September 27th, 2024

Addendum #1

Project Title: Capital Fund Program Improvements for **The Asbury Park Housing Authority**
New Common Area Flooring Work with Wall Base at
Lumley Homes A/B located at 1004 Comstock Street & 1025 Second Avenue
Comstock Court located at 1018 First Avenue
Dr. Robinson Towers located at 1000 ½ Third Avenue
Asbury Park, NJ 07712

Sheet Number
A-102.00

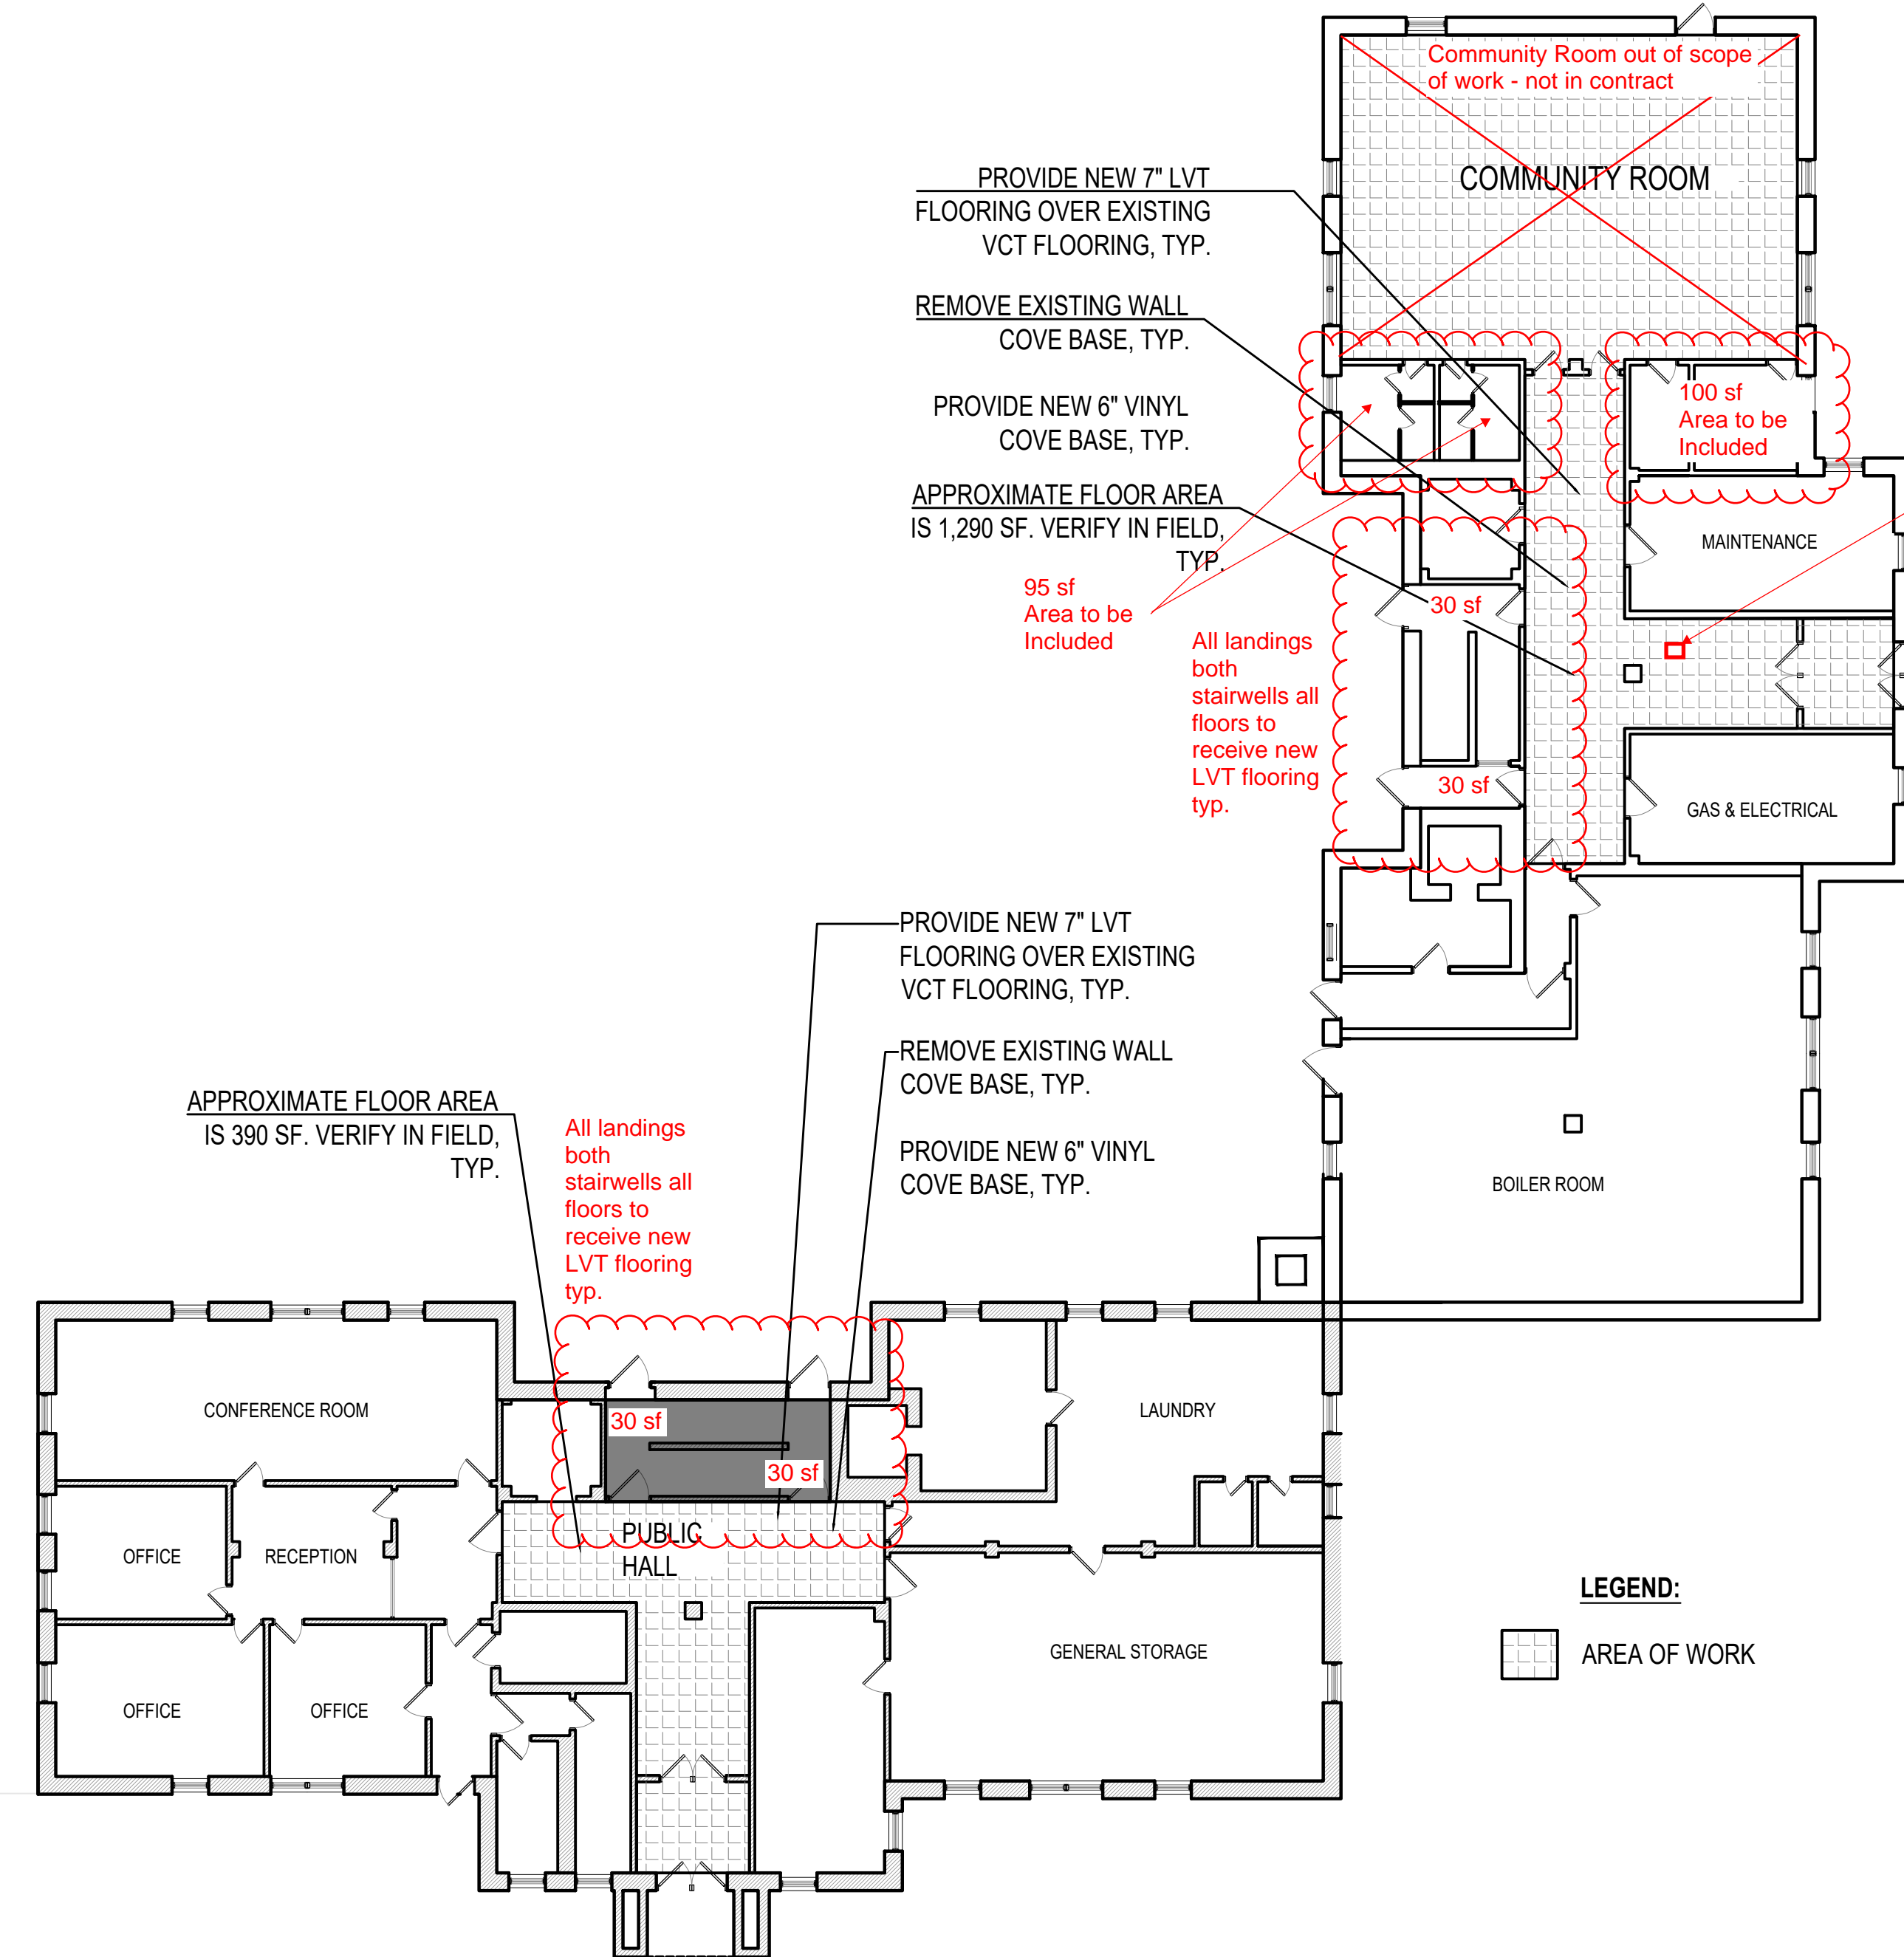
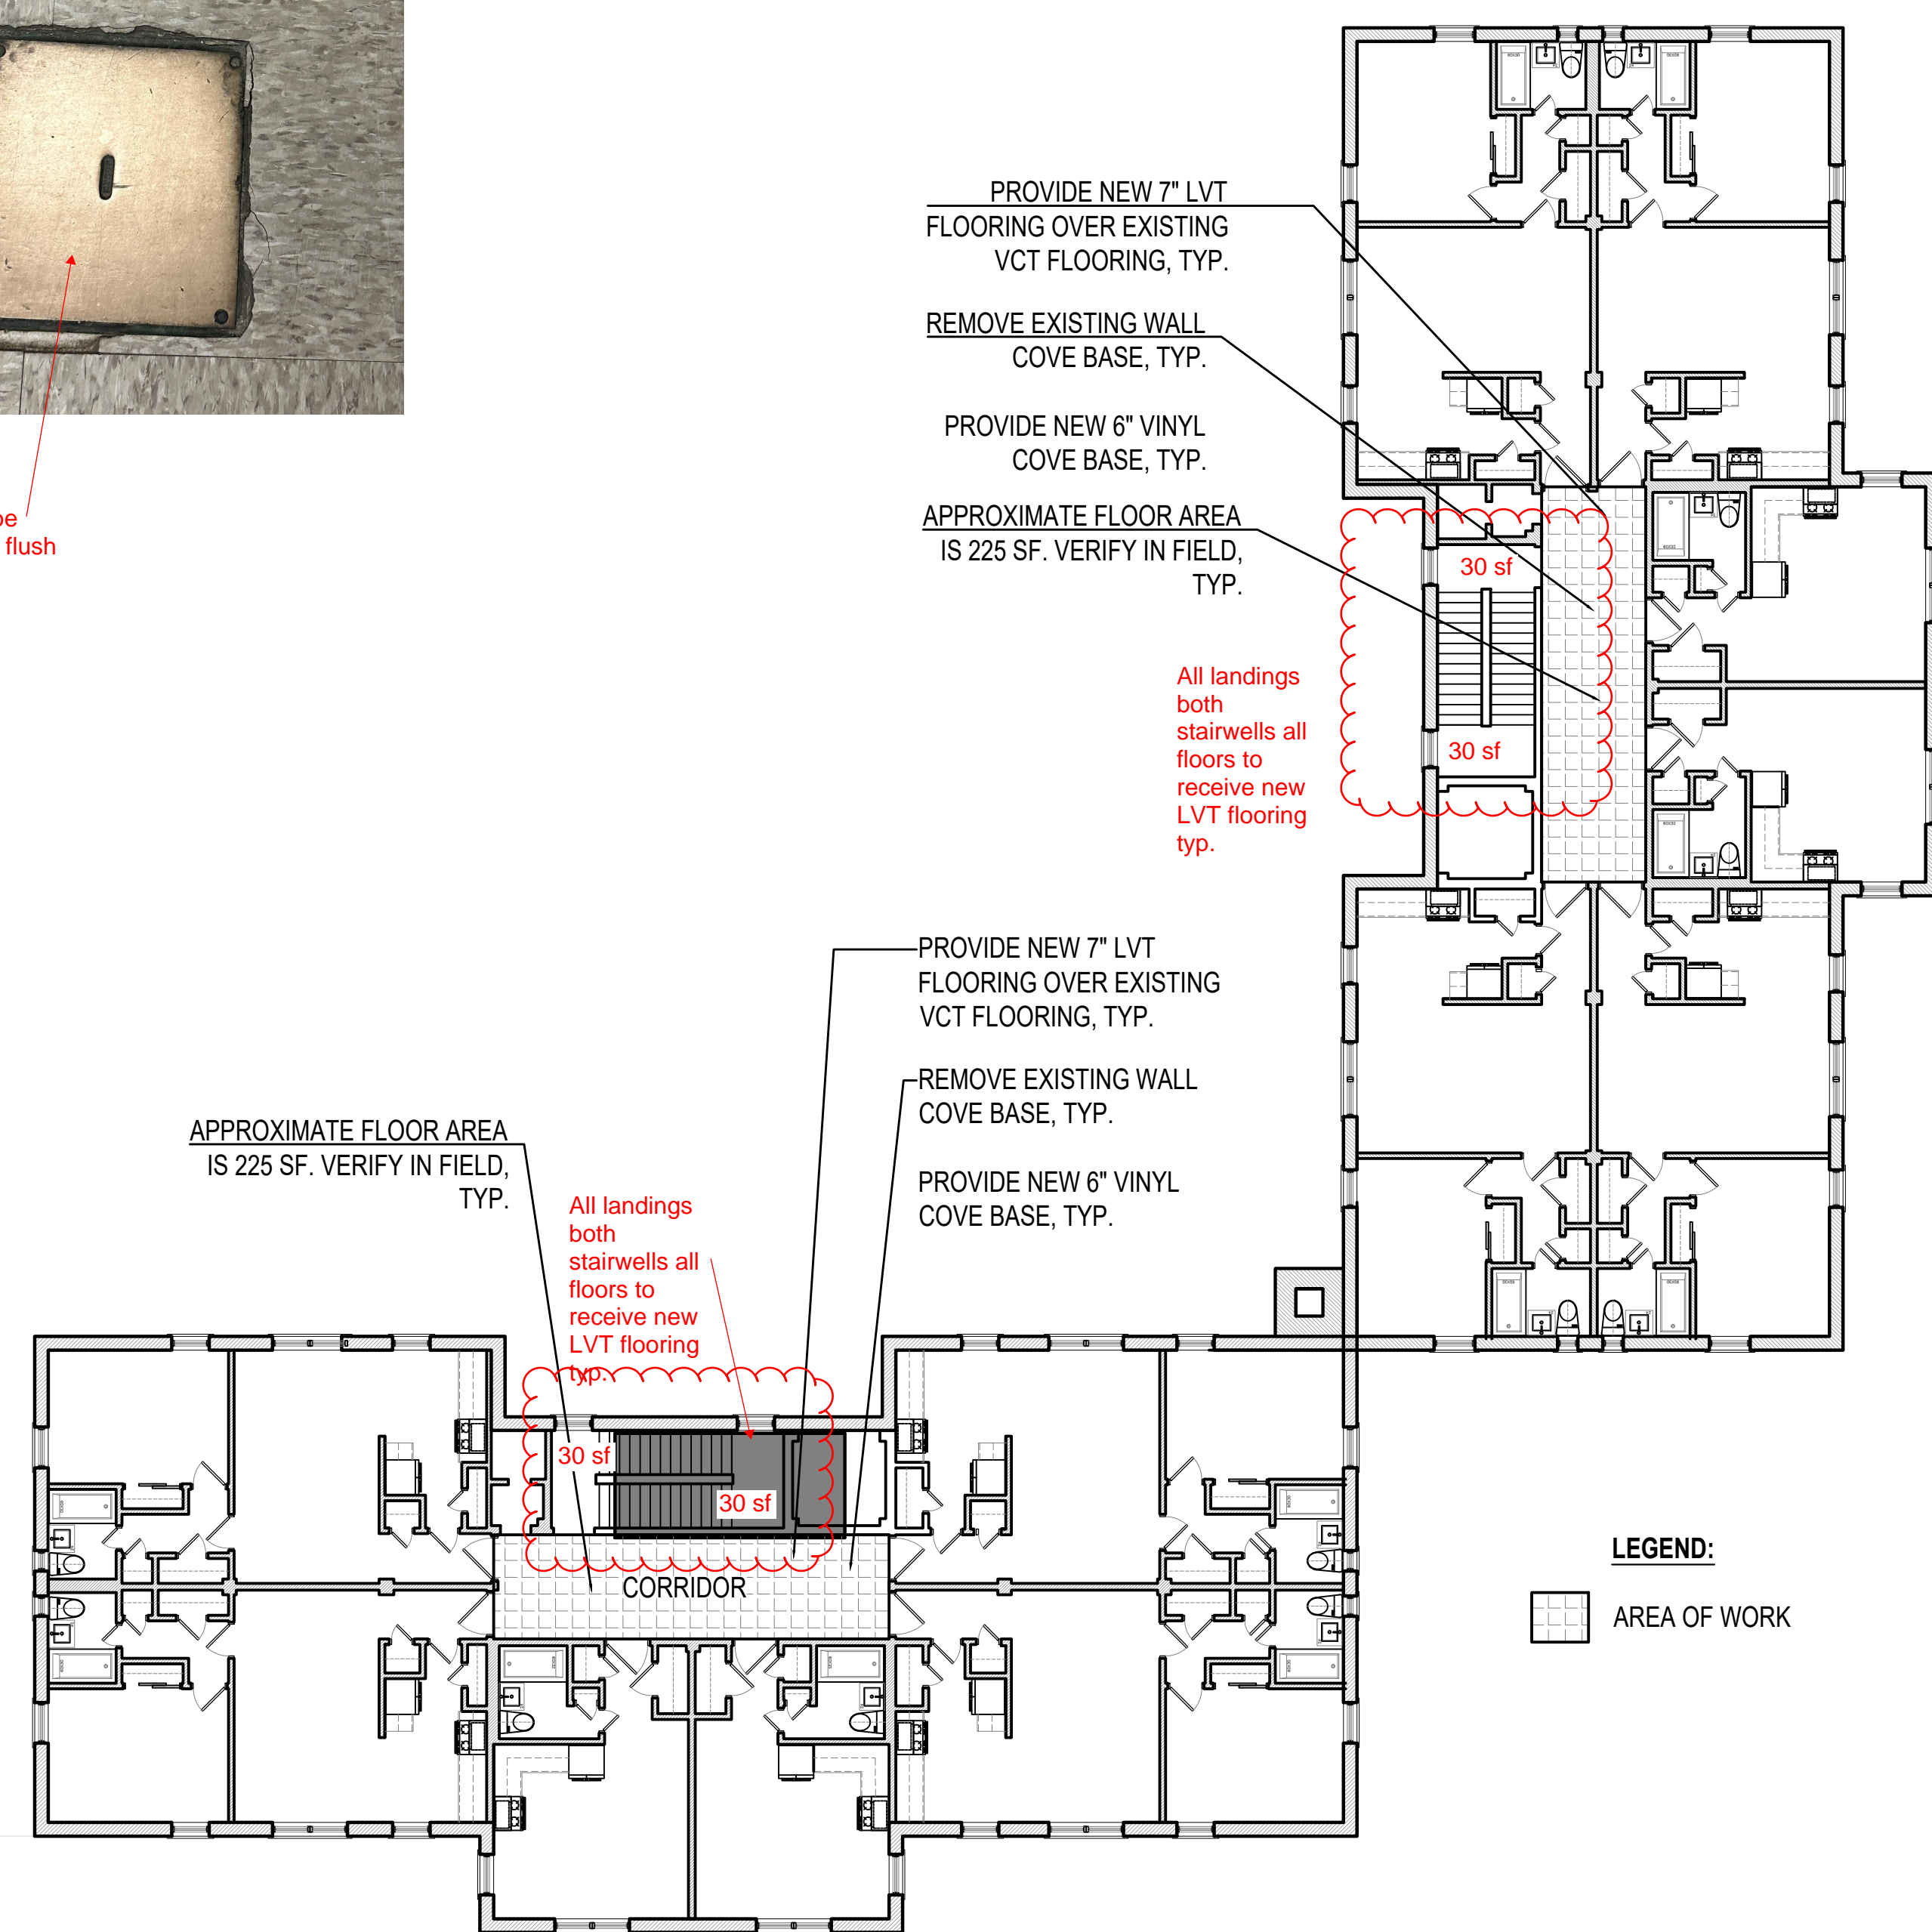
For Lumley Homes – Sheet A-102.00 Attached

8. All Stairwell landings (two stairs in total – mid & top/bottom) are to receive new flooring as per the base scope of work. There are 8 floors within this structure. Contractor required to provide reducers & trim pieces as needed to smooth transition of LVT to stairs & thresholds.
9. Community Room has been removed from scope of work
10. Pre-existing community room bathroom & kitchen are to be included.
11. Existing square floor box to be lifted and raised to new elevation and then cut into the new flooring. LVT tile to finish flush to clean out flange.

Pre-existing floor box to be raised. New LVT to finish flush with perimeter flange.
